# Whitemoss Landfill Response to Environmental Permit Application

Prepared for: ARROW

Date: 07/12/2014

Reference: 30047R2D3

Figure 3.1 Concentrations of ammoniacal nitrogen in groundwater

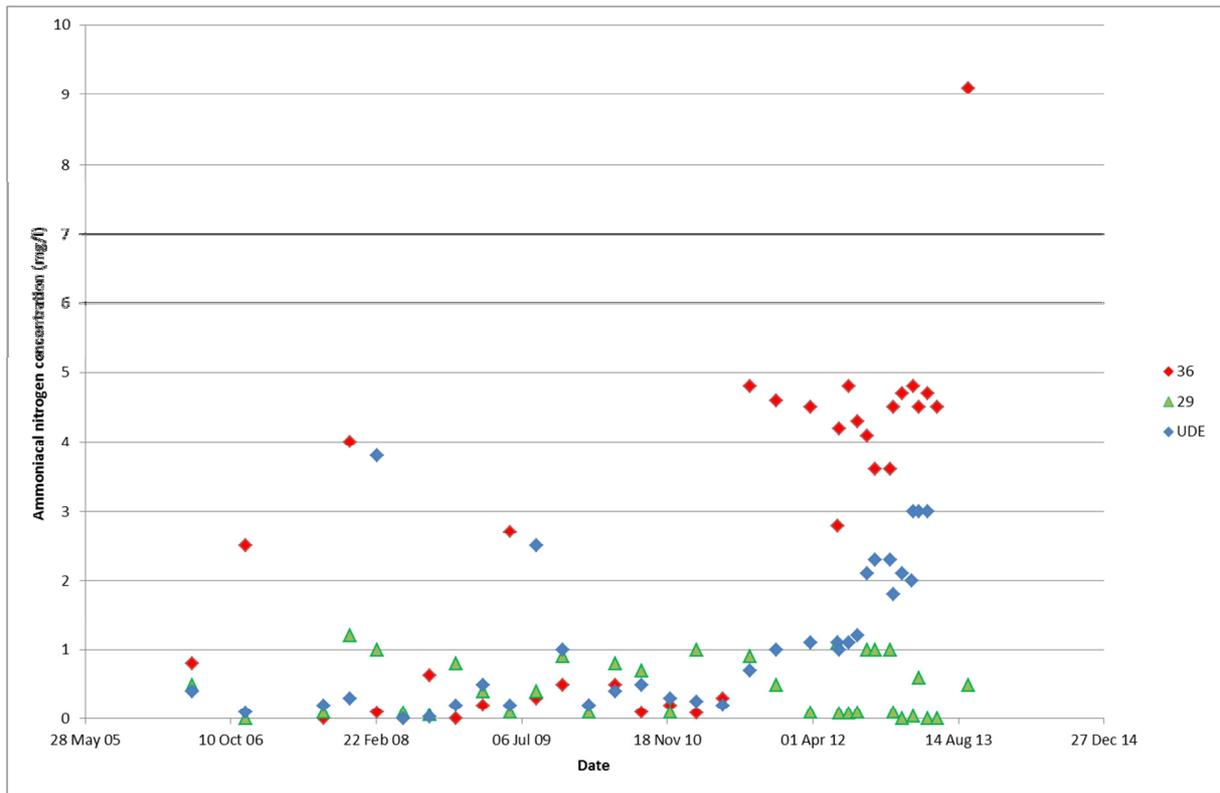
The data indicate that for chloride and ammoniacal nitrogen, a clear upward trend is evident in the data for some locations. The trend is clearest in BH36 and the underdrainage effluent (UDE), but may also be present in data from BH26, BH28, BH34 and BH40. These boreholes are all located around the central area of the current landfill (BH40 and BH36 on the eastern boundary and BH28 and BH26 on the western boundary). The spatial grouping of the boreholes indicates that there is a local effect causing the trend in concentrations.

To clearly illustrate the trend, Figure 3.1 shows ammoniacal nitrogen concentrations in groundwater through time, at BH36, BH29 and the underdrainage effluent (UDE). Figure 3.2 shows the same information for Chloride. It is evident that the concentration of ammoniacal nitrogen and chloride are increasing in BH36 and the UDE, compared with a steady concentration at BH29.

These data have significant implications regarding the integrity of the existing containment system. The observed trends may be due to a breach in landfill liner and migration of leachate to the affected boreholes. The maximum measured concentration of ammoniacal nitrogen at BH36 is 9.1 mg/l, which compares with an EQS of 1 mg/l<sup>1</sup>, a drinking water standard of 0.5 mg/l<sup>2</sup> and a current trigger level of 0.005 mg/l (n.b. the current permit sets a trigger level of 5 ug/l for ammoniacal nitrogen; Whitemoss Landfill monitoring data state the trigger level to be '5' with no units specified, however all other ammoniacal data are presented in mg/l. The minimum reporting level (MRL) for ammoniacal nitrogen is 0.05 mg/l. There is therefore a discrepancy between the trigger level as permitted, the MRL and the trigger level used in environmental monitoring and reporting).
